RENESAS TECHNICAL UPDATE

Product Category	MPU/MCU		Document No.	TN-RX*-A0278A/E	Rev.	1.00
Title	Errata Regarding Setting of the RCR4.RCKSEL Bit for the RX64M Group and RX71M Group MCUs		Information Category	Technical Notification		
Applicable Product	RX64M Group, RX71M Group	Lot No.	Reference Document	User's Manual: Hardware for applicable products listed under Related Documents on the last page		
		All

Figure 9.11 Example Flowchart of Initialization when the Sub-Clock is to be Used as the Source to Drive Counting by the Realtime Clock

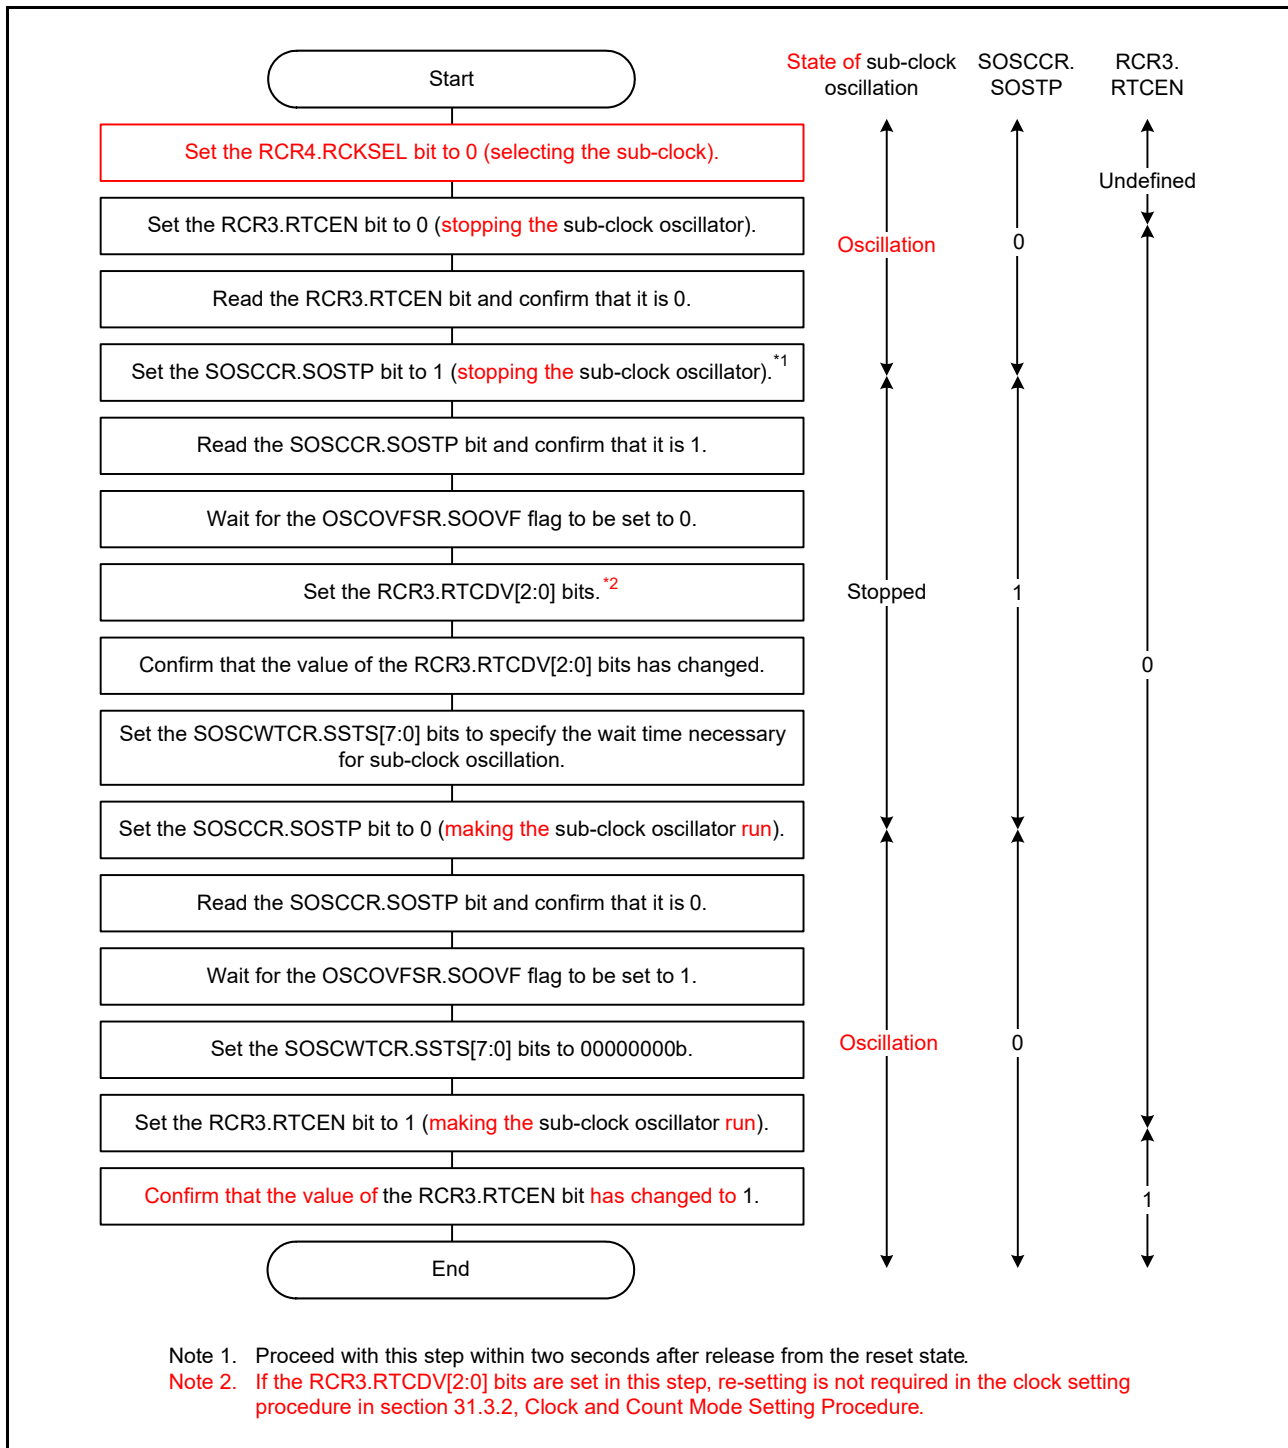
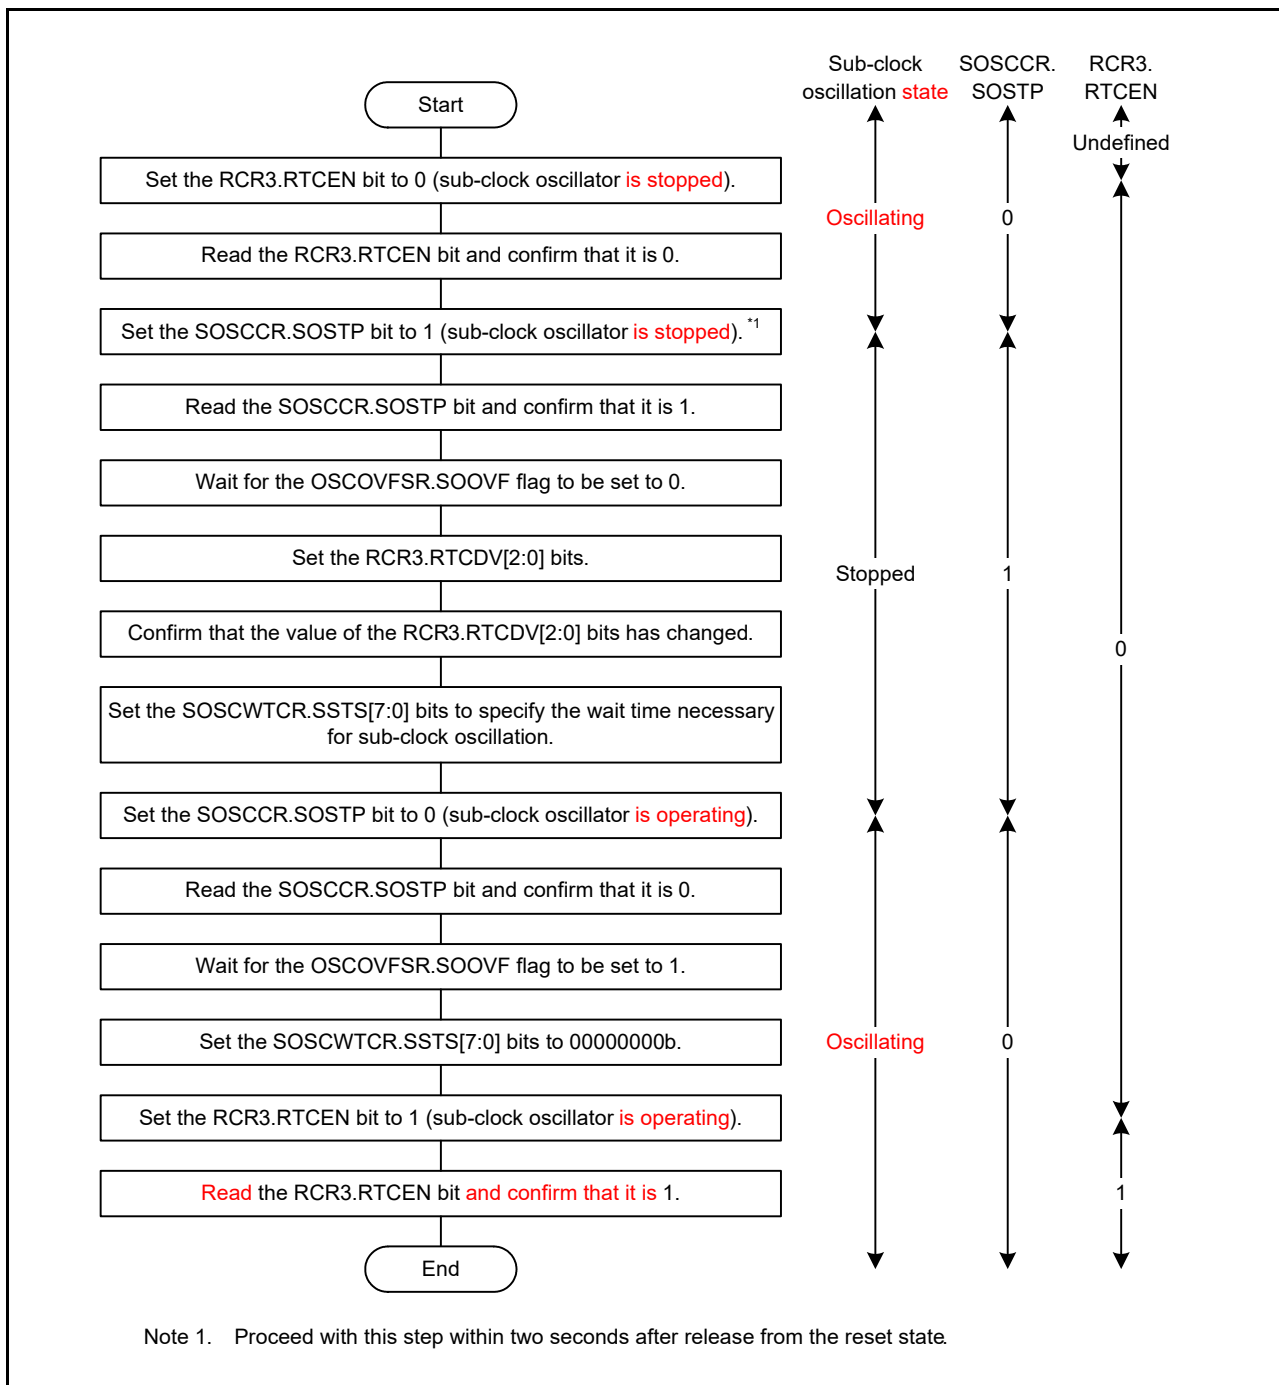
The following deletions are made in Figure 9.11, Example Flowchart of Initialization when the Sub-Clock is to be Used as the Source to Drive Counting by the Realtime Clock.

- The RCR4.RCKSEL bit setting
- Note 2

The title of Figure 9.11 is also modified.

Figure 9.11 Example of Initialization Flowchart When the Sub-Clock Is to Be Used as the Clock Source for the RTC

Figure 9.12 Example Flowchart for Initialization when the Sub-Clock is to be Used only as the System Clock

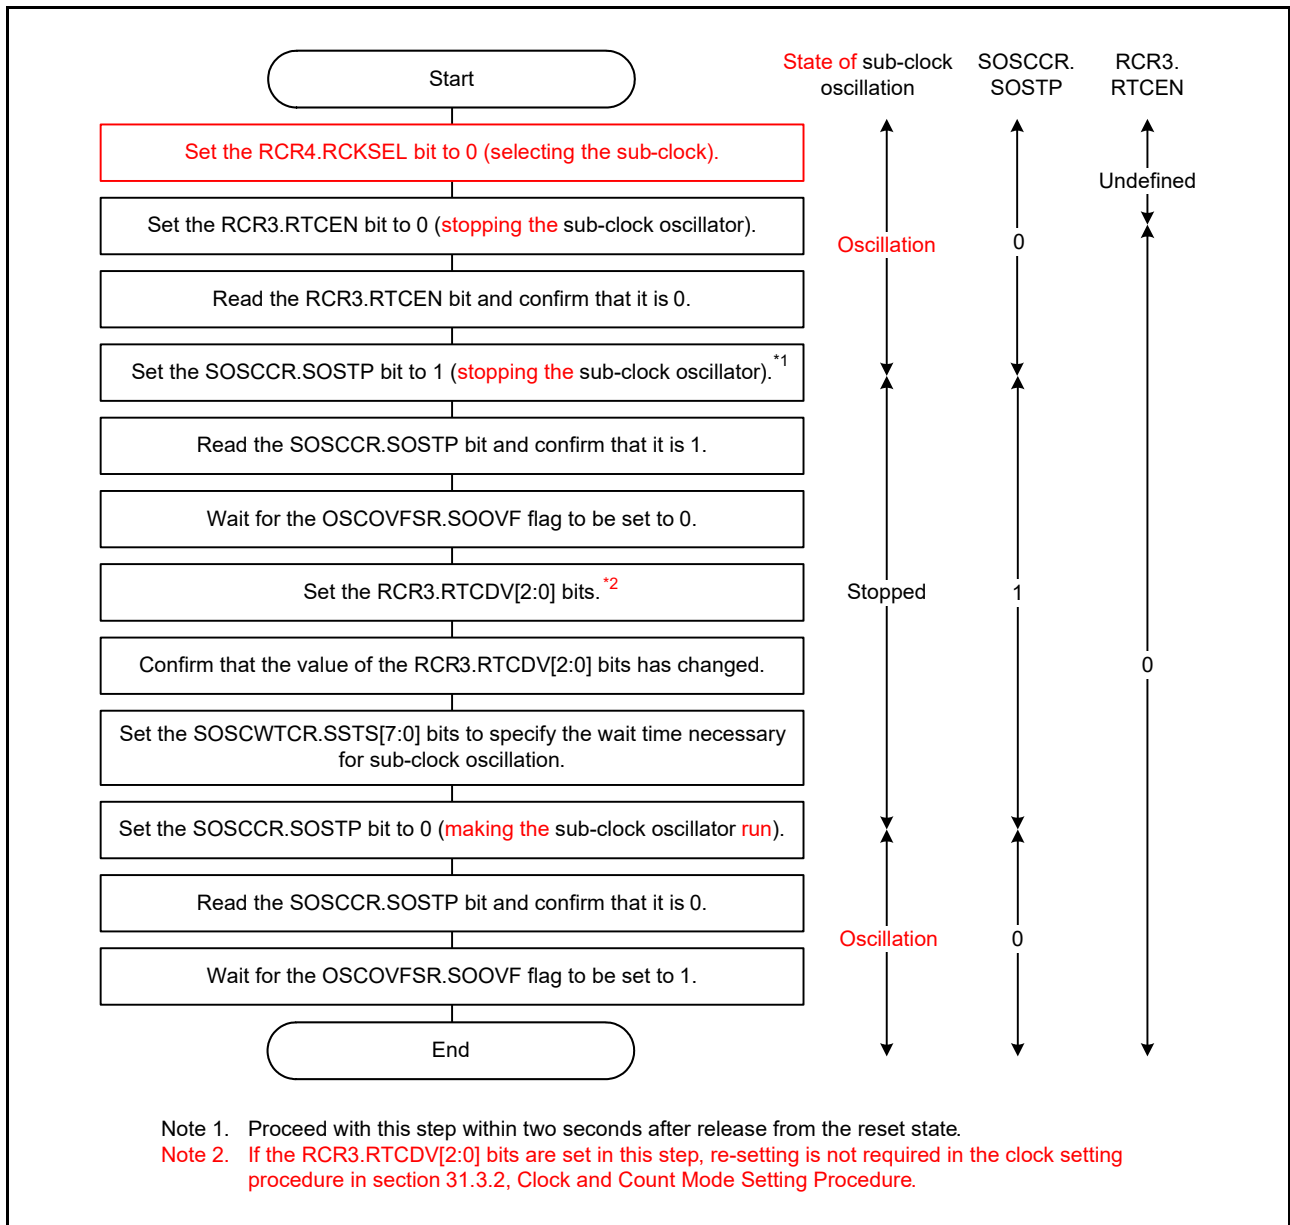
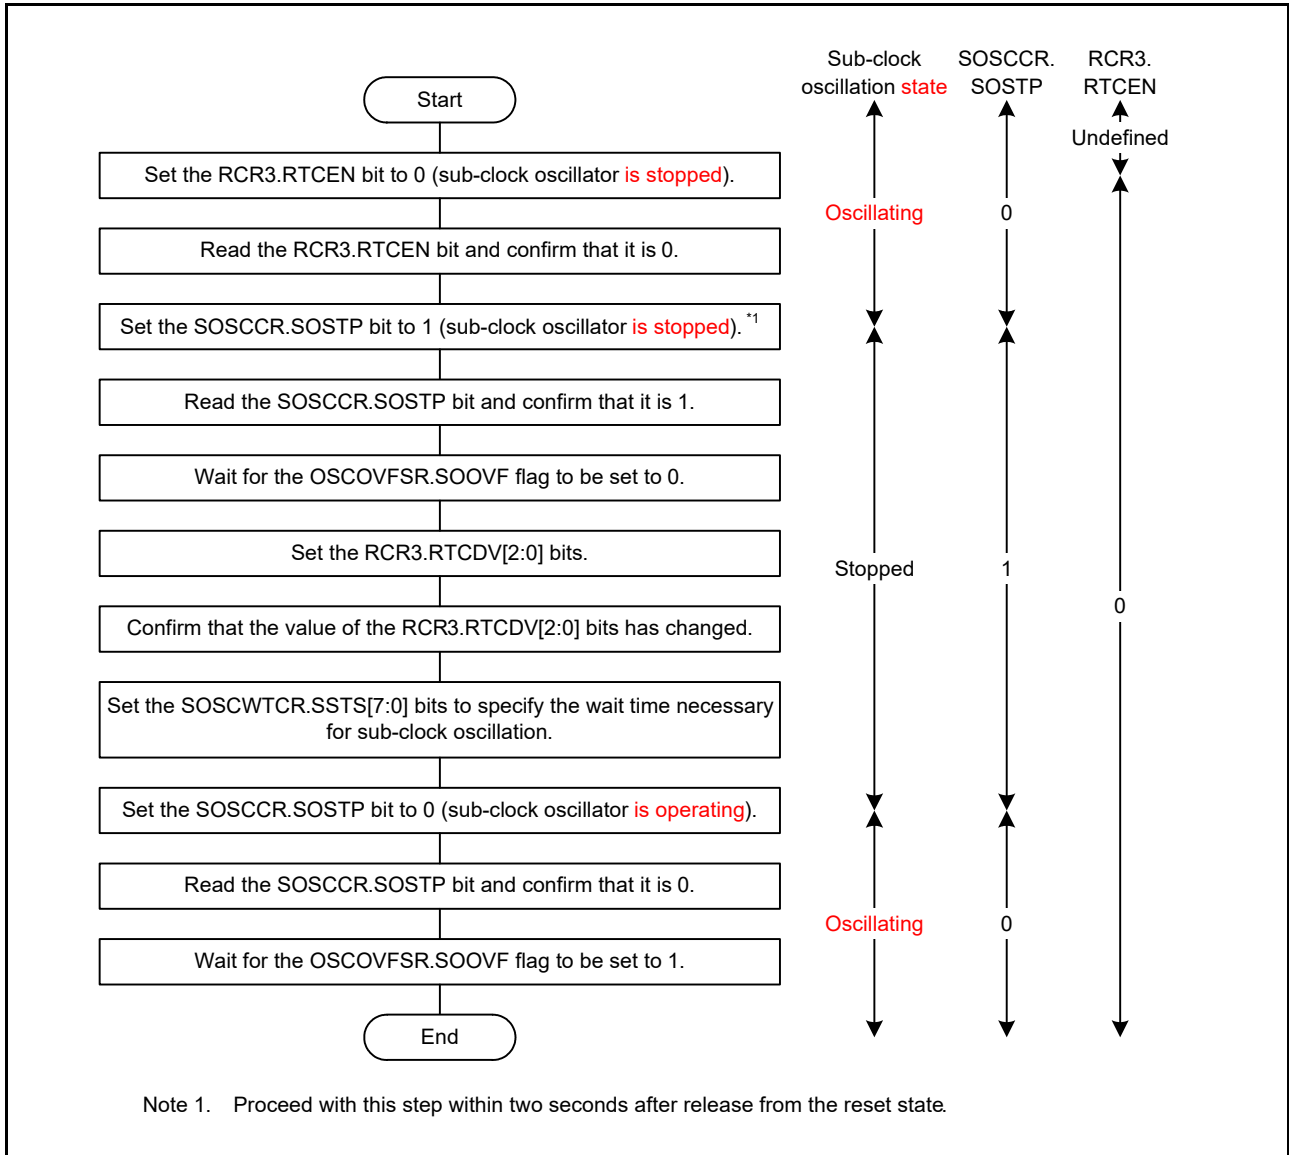
The following deletions are made in Figure 9.12, Example Flowchart for Initialization when the Sub-Clock is to be Used only as the System Clock.

- The RCR4.RCKSEL bit setting
- Note 2

The title of Figure 9.12 is also modified.

Figure 9.12 Example of Initialization Flowchart When the Sub-Clock is Not to Be Used as the Clock Source for the RTC

Figure 9.13 Example Flowchart for when the Sub-Clock is not to be Used

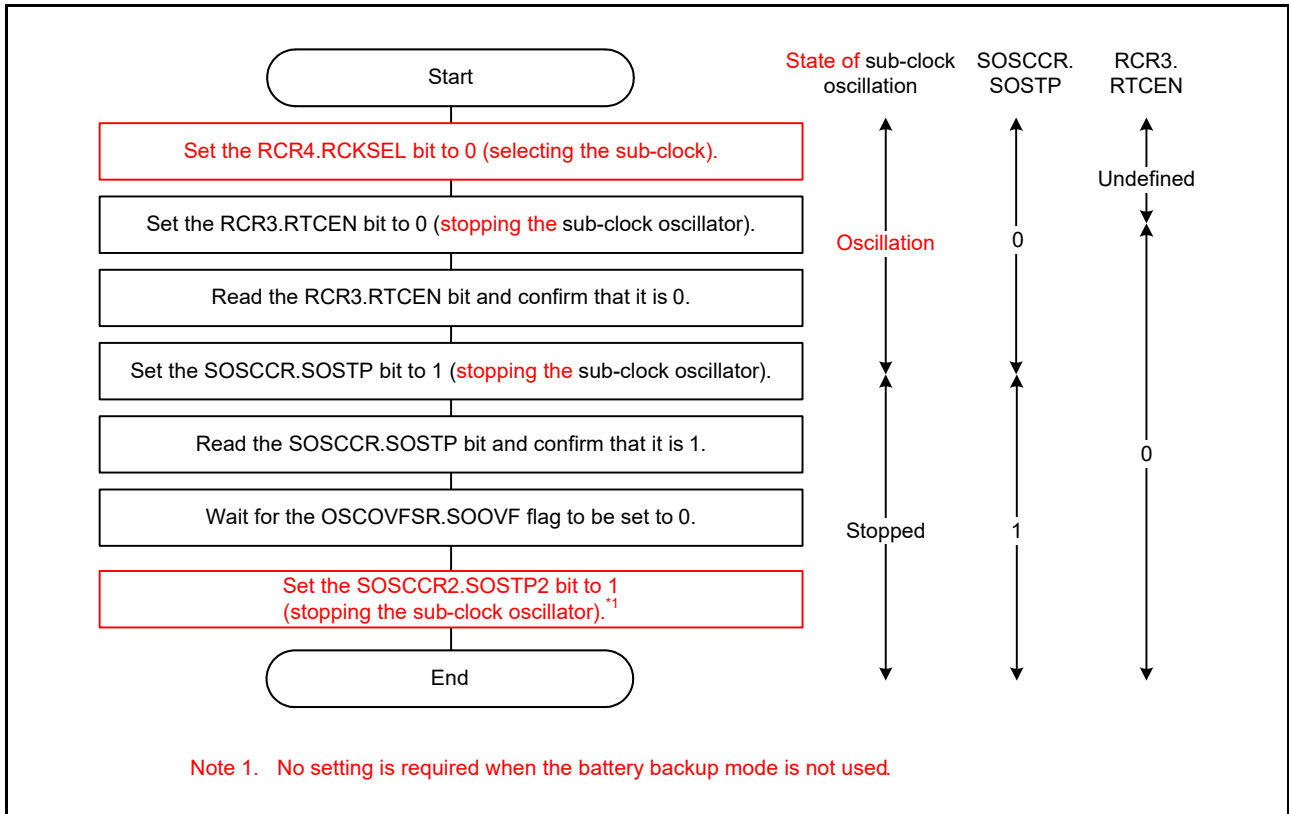
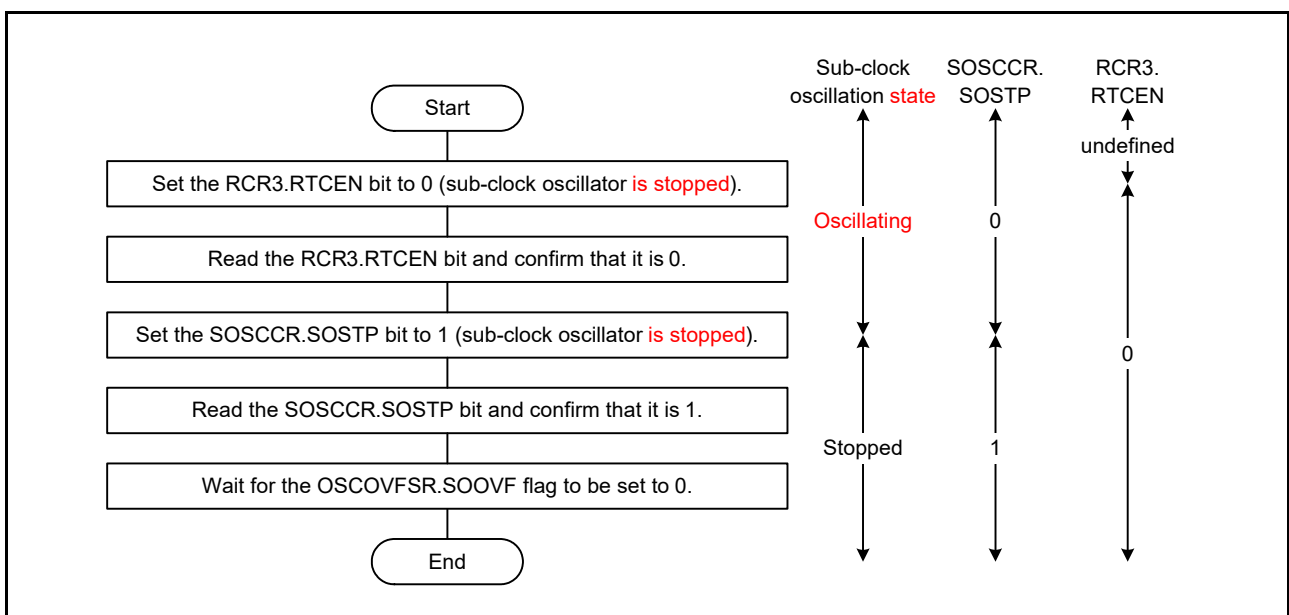
The following deletions are made in Figure 9.13, Example Flowchart for when the Sub-Clock is not to be Used.

- The RCR4.RCKSEL bit setting
- The SOSCCR2.SOSTP2 bit setting
- Note 1

Figure 9.13 Example of Initialization Flowchart When the Sub-Clock Is Not to be Used
